Appin Road Upgrade, Mount Gilead to Ambarvale

Submissions report

Roads and Maritime Services | March 2019

Figure ES-1: Additional fauna fencing along western side of Appin Road at Noorumba Reserve

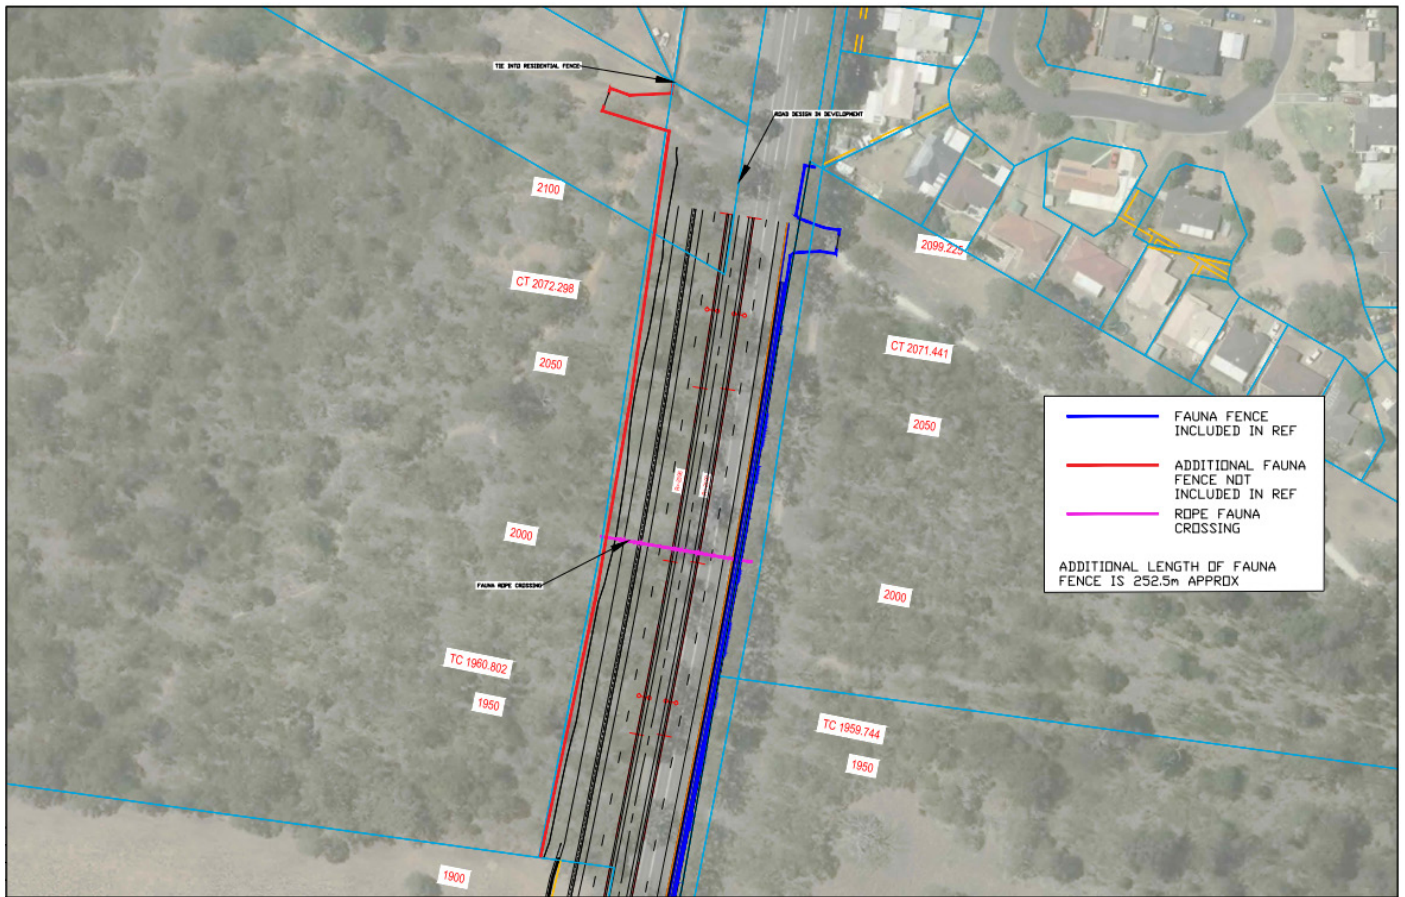
The REF proposal included the provision of a fauna fence and/or barriers at suitable locations on either side of Appin Road to prevent fauna accessing the road corridor. The proposed fauna fencing was predominantly focussed on the eastern side of Appin Road. However, the proposed change would result in the addition of about 252 metres of fauna fencing along the western side of Appin Road at Noorumba Reserve (refer to Figure ES-1).

The proposed change has been implemented based on the feedback and recommendations from OEH, independent expert reports and consideration of submissions raised by the community and key stakeholders.

As no additional vegetation clearing would be required beyond that proposed in the REF, the impacts of this change are consistent with those identified in the REF.

Figure 3-1: Proposed fauna fencing at Noorumba Reserve

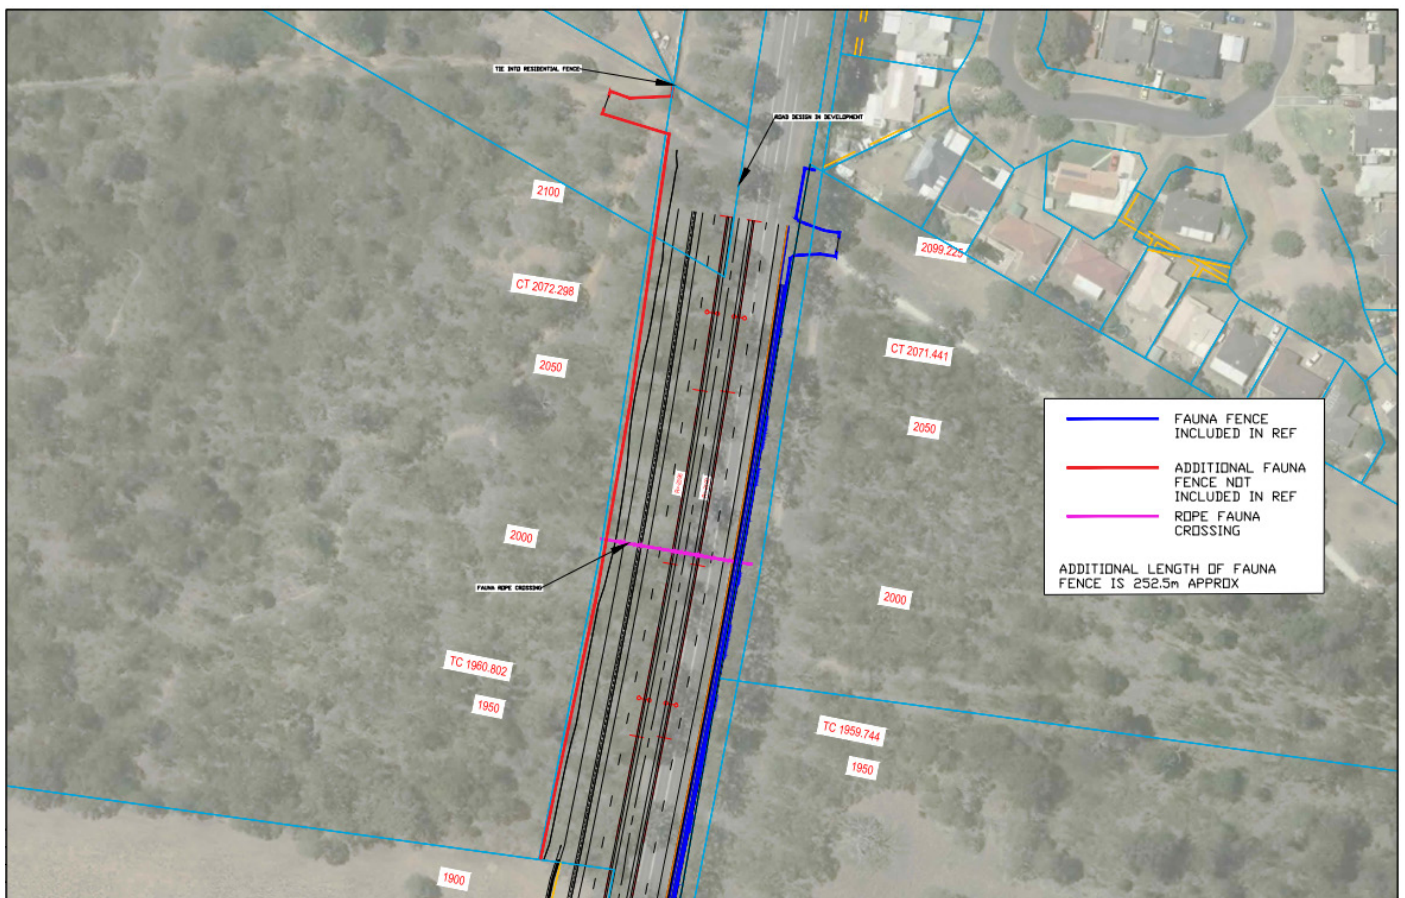
The REF proposal included the provision of a fauna fence and/or barriers at suitable locations on either side of Appin Road to prevent fauna accessing the road corridor. The proposed fauna fencing was predominantly focussed on the eastern side of Appin Road. However, the proposed change would result in the addition of about 252 m of fauna fencing along the western side of Appin Road at Noorumba Reserve (refer to Figure 3-1).

The proposed change has been implemented based on the feedback and recommendations from OEH, independent expert reports and consideration of submissions raised by the community and key stakeholders.

Figure 3-2 Typical cross-section of the fauna fence

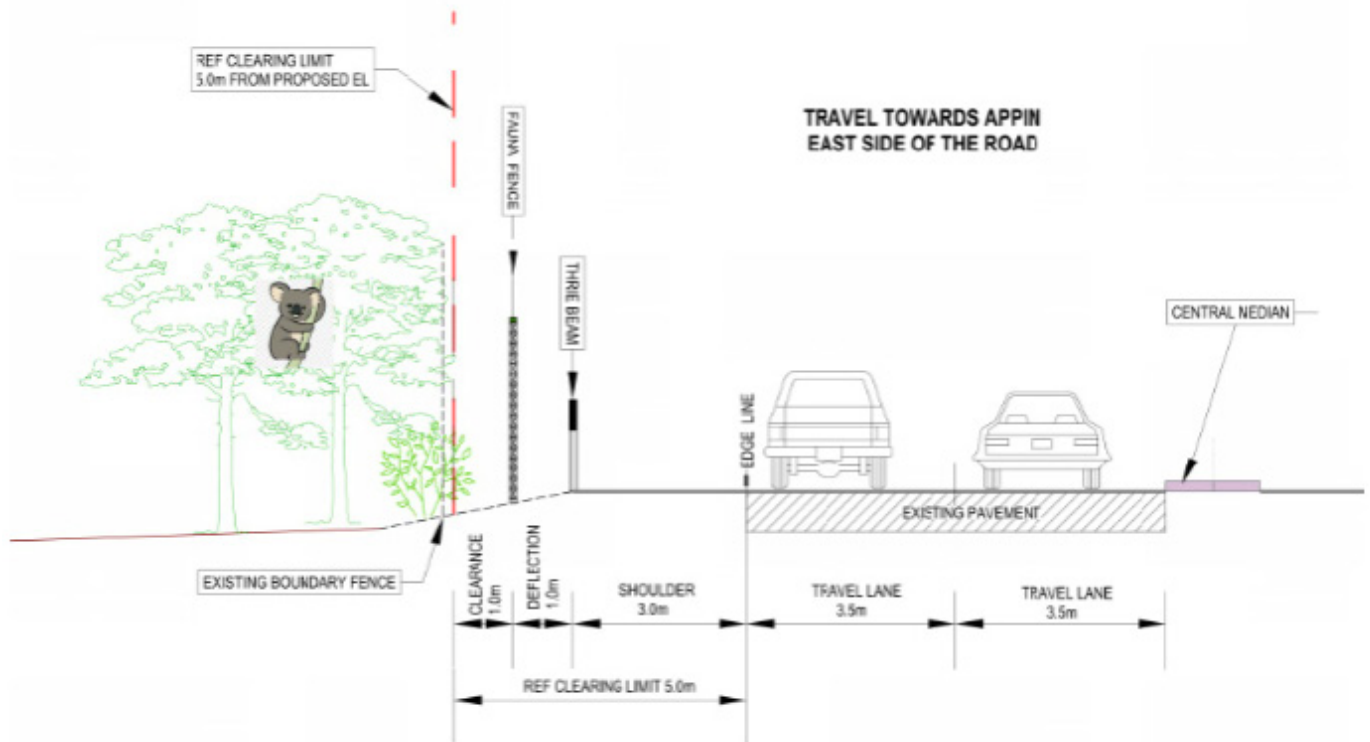
Similar to the proposed fencing in the REF, the fauna fence would typically comprise a 1.8 m chain wire fence with a galvanised sheet at the top to prevent climbing of fauna.

As identified in section 3.2 of the REF, clearing of up to five metres from the existing road pavement would be required for the installation of the fauna fence, safety barrier and to provide access for maintenance and repairs. A section of about 600 m in length would require a six metres cleared zone to accommodate installation of a culvert. The typical five metres cross-section for the fauna fence is shown in Figure 3-2 below.
